**ADDENDUM No.1
for
INVITATION FOR BID (IFB)**

Fire Station Recoating of Apparatus Floor

**TOWN OF LONGMEADOW
MASSACHUSETTS**

April 1, 2019

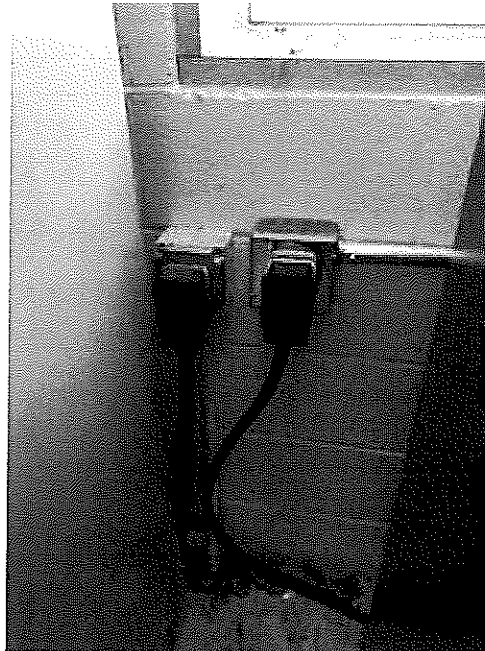
QUESTION: Bidder inquired about electrical service/power for equipment.

RESPONSE: There are two (2) 220V outlets located on the westerly wall inside the Apparatus Room. They are currently behind stored items but these items will be removed by the fire department prior to surrender of the space to the awarded contractor. (Between the grey and red cabinets pictured below.)
